SUBJECT: Evaluates 790726 fire protection safety evaluation rept for facility & provides info requested per rept. Includes tables re 690224 & 790706 diesel fire pump tests & fire pump.

Re: Nine Mile Point Unit 1  
Docket No.: 50-220  
DPR-63

By letter on July 26, 1979, you transmitted the Fire Protection Safety Evaluation Report for Nine Mile Point Unit 1. The purpose of this letter is to provide Niagara Mohawk's comments on that Safety Evaluation Report, and to provide information requested in that report.

FIGURE 1

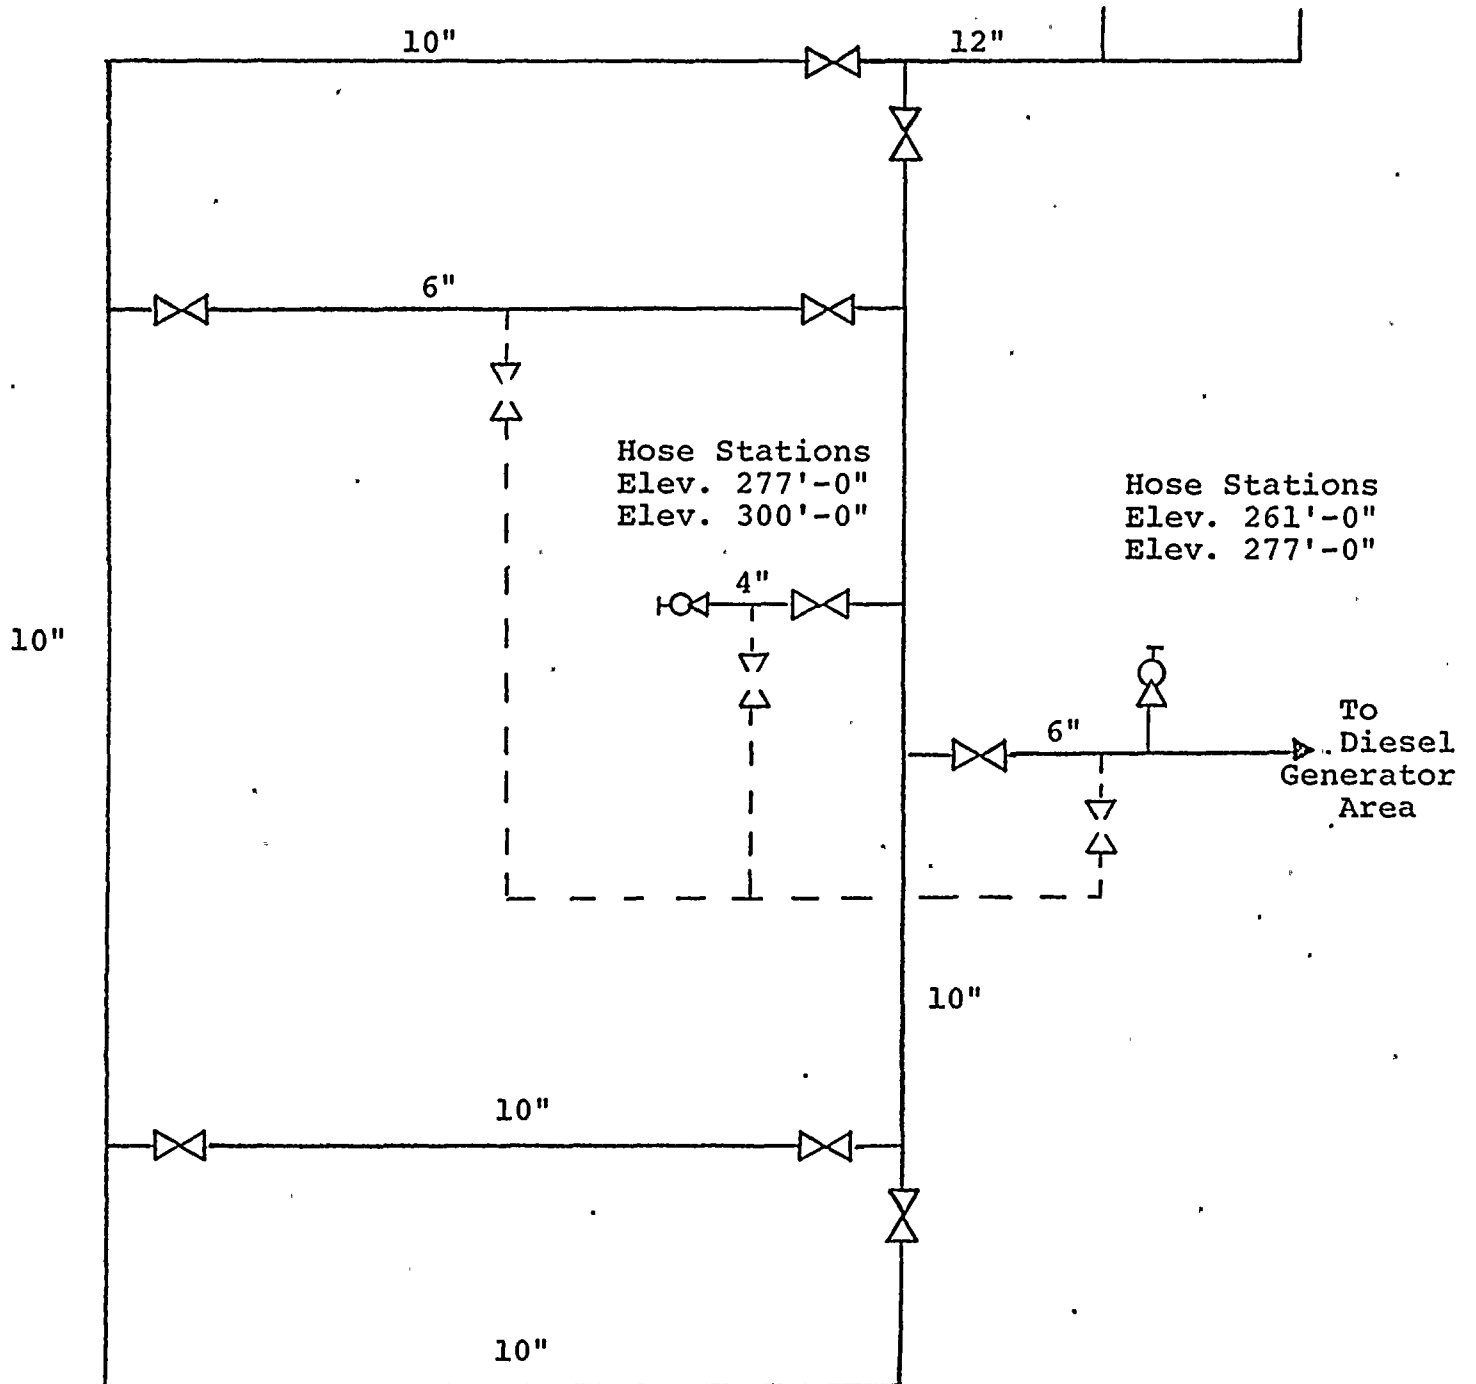
Section 4.3.1.3 requires Niagara Mohawk to submit the details of the modification to the fire water piping system to preclude loss of both automatic suppression system and interior hose stations. The attached Figure 1 details Niagara Mohawk's proposed modification. As shown on Figure 1, three valves and associated piping are being added. After installation of this equipment, the valve connections and piping will be hydro tested to 1-1/2 times normal operating pressure.
